# Report Committee of Adjustment

Filing Date: Hearing Date:	January 10 <sup>th</sup> , 2023 February 14 <sup>th</sup> 2023
File: Owner/ Applicant:	A-2023-0005
	DALJIT KAUR BAL, HARJINDER SINGH BAL, AND HARLEEN KAUR BAL
Address:	30 Marine Drive
Ward:	WARD 9
Contact:	Samantha Dela Pena, Assistant Development Planner

Appendix B – Site Visit Photos:

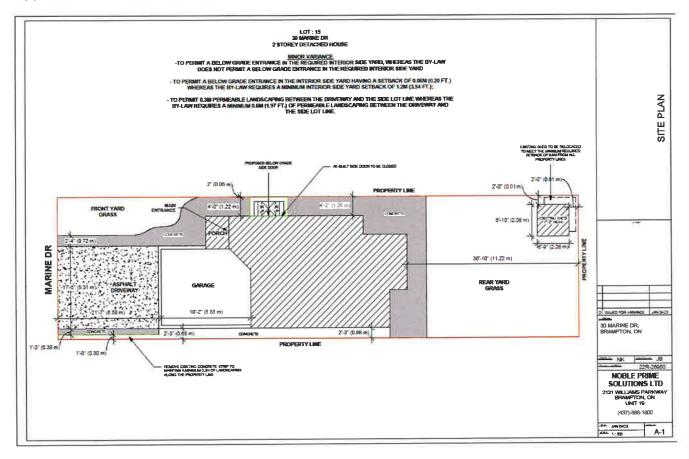
Variance 3 is requested to permit an existing shed having a side and rear yard setback of 0.15m (0.50 ft.), whereas the by-law requires a minimum setback of 0.60m (2.0 ft.) to the nearest lot lines for an accessory structure. The requested variance is not minor in nature as it does not provide adequate area for drainage or access for maintenance of the shed or fencing. As such, staff recommend refusal of the proposed Variance 3 and that the revised site plan provided by the applicant (Appendix A) showcasing a 0.60m (2.0 ft) setback between the side/rear lot line and the edge of the shed be approved.

Variance 4 is requested to permit 0.0m of permeable landscaping between the driveway and the side lot line, whereas the by-law requires a minimum 0.60m (2.0 ft.) of permeable landscaping between the driveway and the side lot line. The requested variance is not minor in nature as it does not provide sufficient soft scaping on the front yard as the existing condition of the front yard area is predominantly concrete between the driveway and side lot line. Therefore, staff recommends that Variance 4 be refused and that the revised site plan provided by the applicant (Appendix A) showcasing a 0.3m (1.0 ft) permeable landscaping strip between the driveway and the side lot line be approved to ensure appropriate development of the land.

- 3. That Variance 3 to permit a shed located 0.15m (0.49 ft) from the side and rear lot line be refused. Staff recommend that approval be based on the revised site plan provided by the applicant (Appendix A) showcasing a 0.60m (2.0 ft) setback between the side/rear lot line and the edge of the shed;

- 4. That Variance 4 to permit 0.0m (0.0 ft) of permeable landscaping between the driveway and the side lot line whereas the by-law requires a minimum of 0.60m (2.0 ft) of permeable landscaping between the driveway and the side lot line be refused. Staff recommend that approval be based on the revised site plan provided by the applicant (Appendix A) showcasing a 0.30m (1.0 ft) permeable landscaping strip between the driveway and the side lot line;
